File No.: 04-1000-20-2020-387

Re: **Request for Access to Records under the Freedom of Information and Protection of Privacy Act (the "Act")**

CITY OF VANCOUVER  
ENGINEERING SERVICES

**RESIDENTIAL DEVELOPMENT**  
KING EDWARD AVENUE, WEST OF CAMBIE STREET, VANCOUVER, B.C.  
SHORING - SITE PLAN

**Existing concrete slab under west  
portion of the north neighboring  
building which needs additional  
protection**

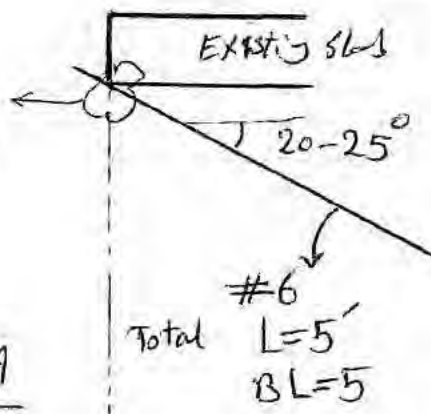
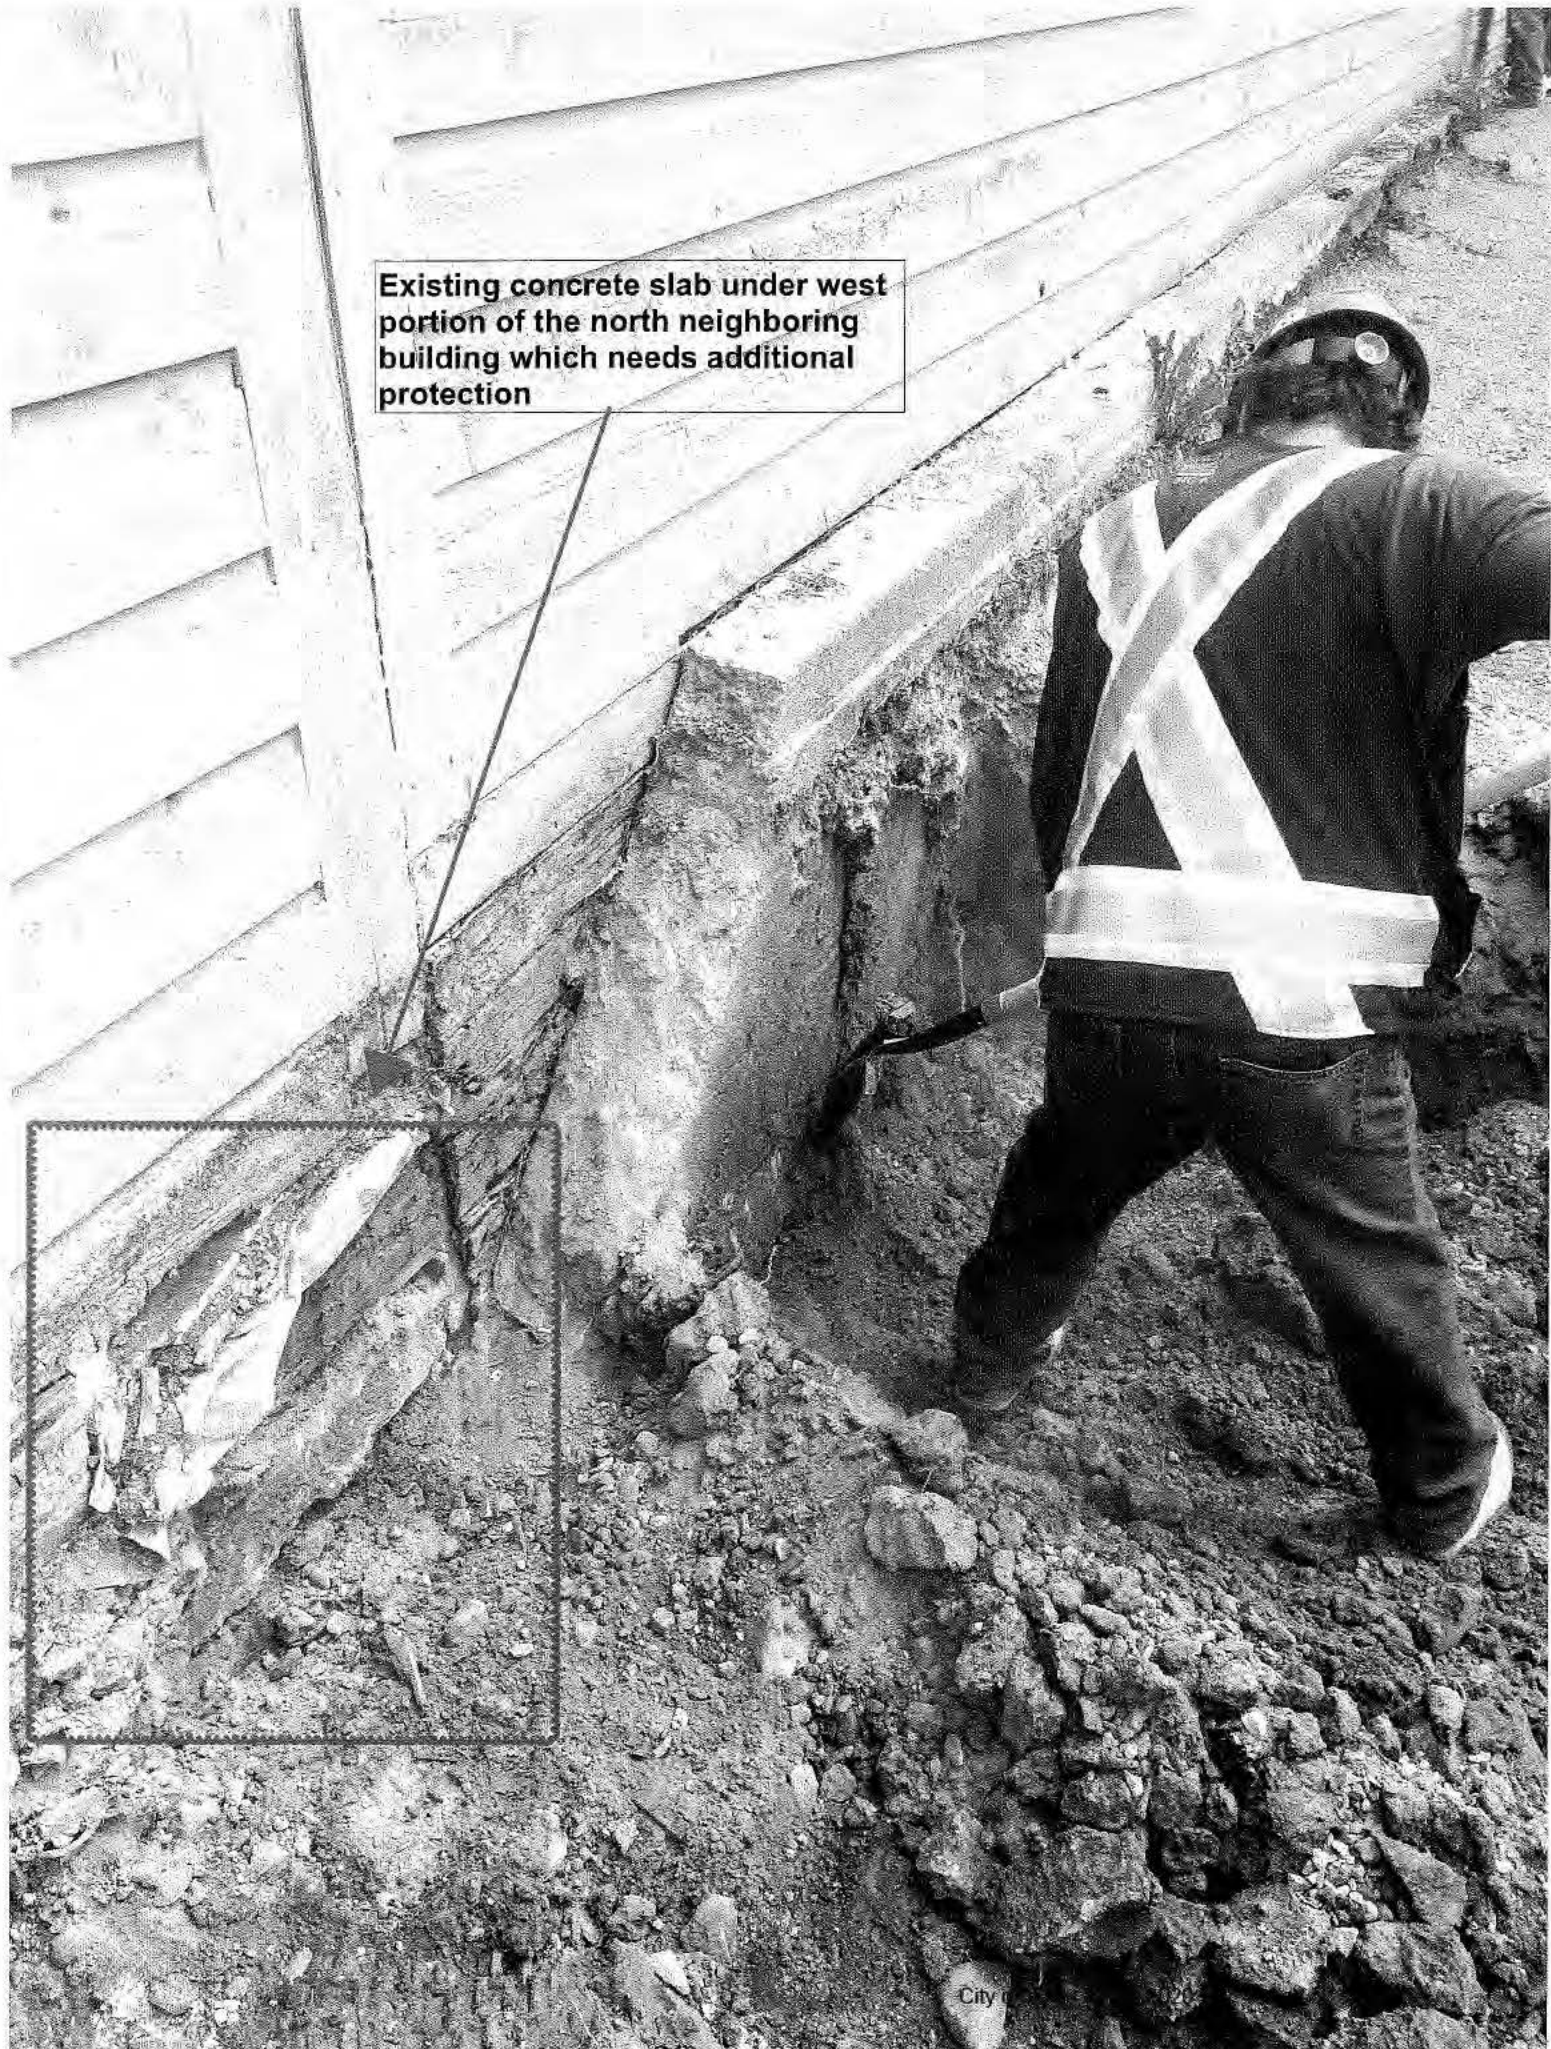
Conclusion and Recommendations: At under side of the slab (at western

of building footprint) additional

Additional Soil  
Nail at 2ft  
horizontal spacingSoil nails are required  
to make sure the slab  
is secured before any  
soil removal.The soil nails should  
be fully bonded and  
drilled right at bottom of  
the slab, and soil should  
not be removed until the groundAdditional ground  
may be needed

TYPICAL POWER POLE SUPPORT DETAIL - SKETCH 1

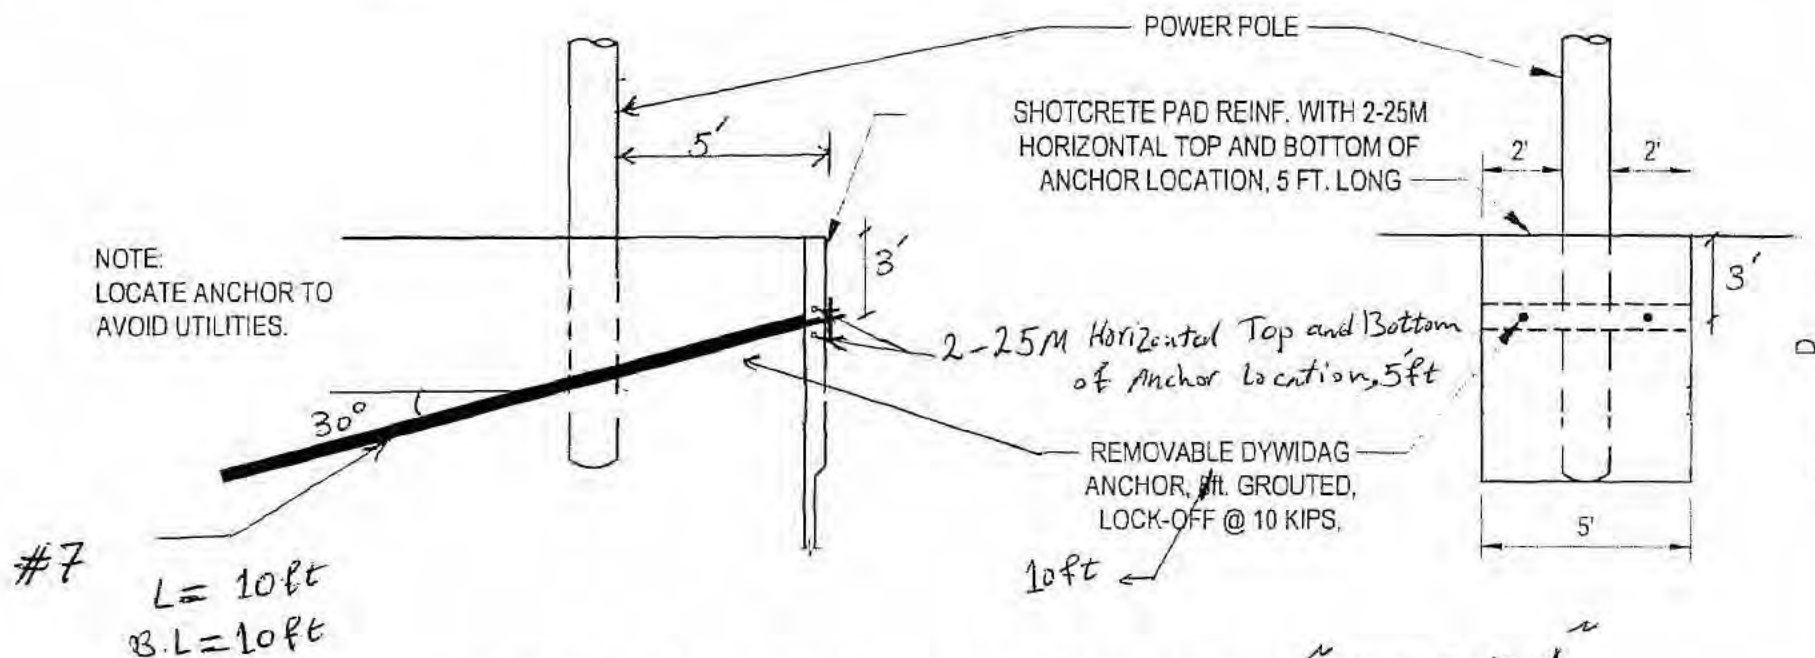
Further to question raised by shoring construction sub-contractor (A&A) regarding additional support at location of power poles along the lane at west side. Exp was on site and reviewed the shoring construction. The power poles were located at about 5' from face of excavation.

In order to provide required clearance from utility lines, required revision of shoring design at west side were made. In general "Typical power pole support detail as provided in shoring design drawing shall be followed. However, Anchor length for first Row shall be installed

ELEVATION LOOKING EAST - SKETCH 1 attached to Memo dated July 6, 2015

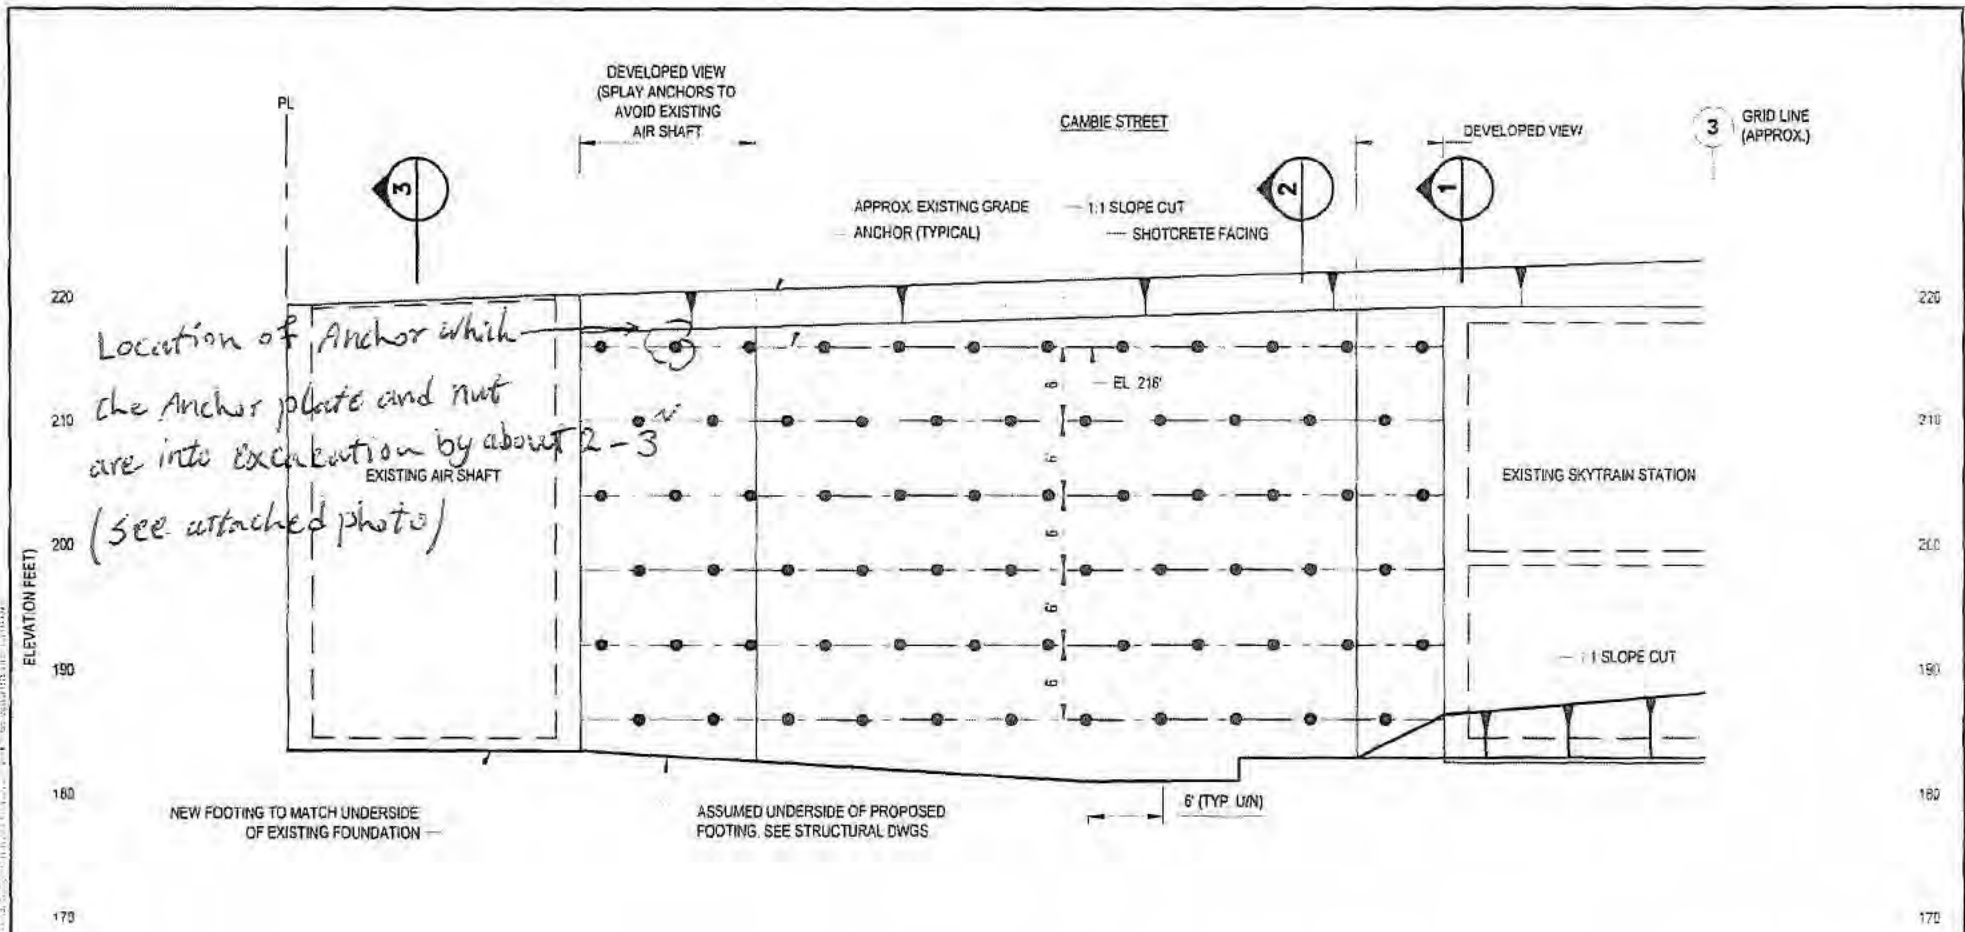
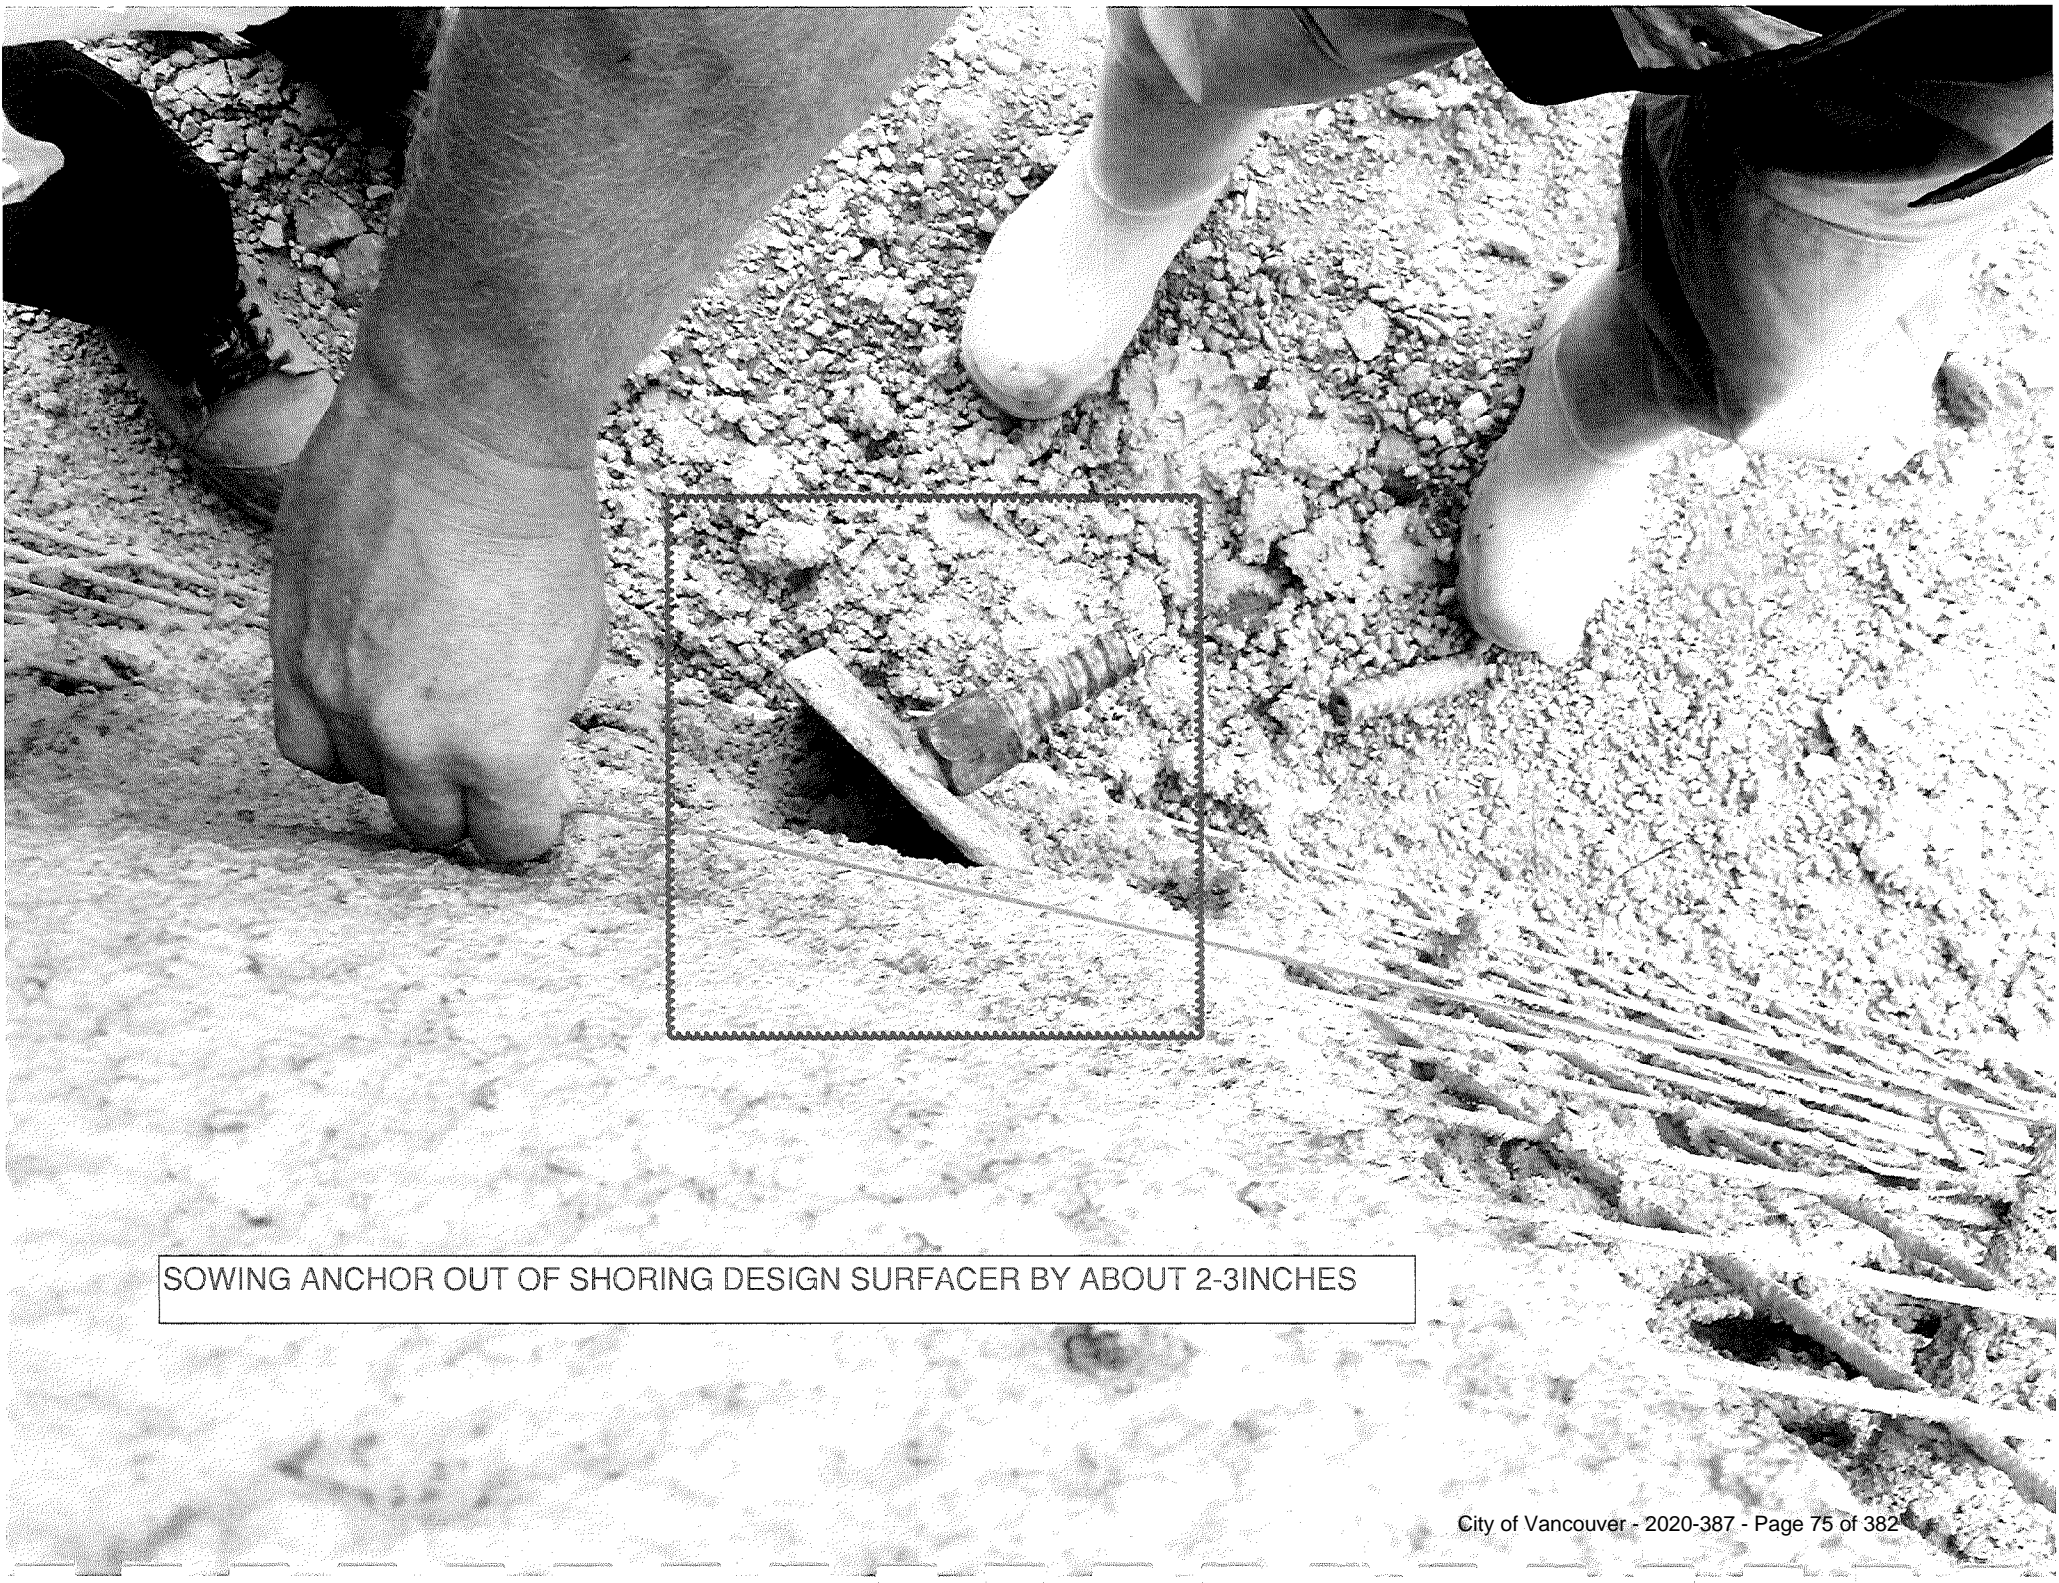
NOTE: one Soil Nail (Memo June 26, 2015) at East of Concrete Slab was not installed (see attached photo of Response to RFI 0003 by exp)

NOTE: Additional Soil Nail at location of power poles along the lane (at West Side) as shown in Design Drawing G15 were not installed

The additional soil nails at location of the power poles were reviewed and revised as per exp's memo dated July 3, 2015. The sub-contractor (AXA) representative was informed for the missing soil nails on Saturday (July 4th) and subsequently on Monday July 6, 2015 (see attached photo)

Looking North - Section A-A (page 1)

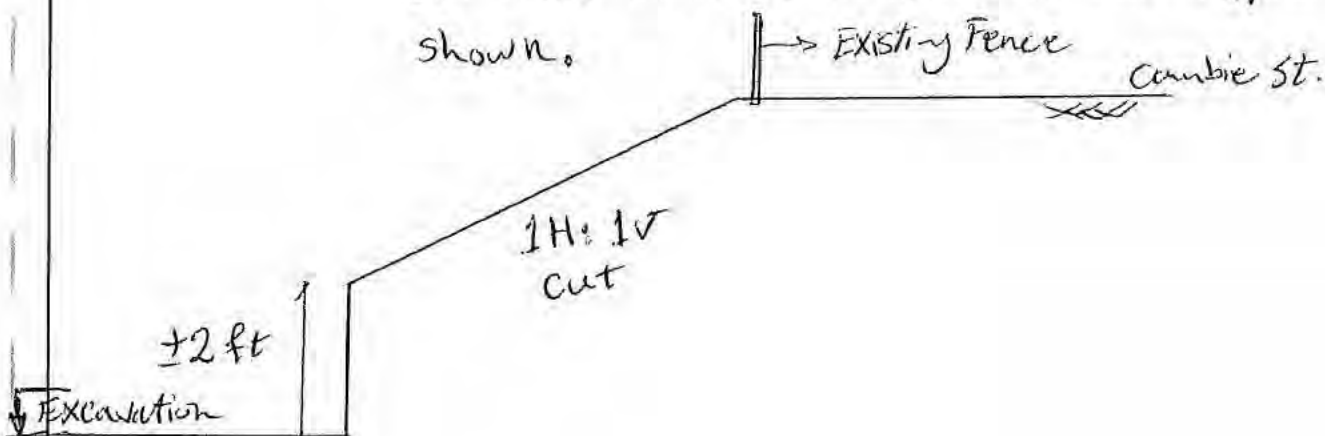
Conclusions: Temporary cut Slope should not be steeper than 1V:1H, however, there is not enough room for 1:1 cut slope. The slope cut could have 2' vertical cut and sloped 1H:1V as shown.
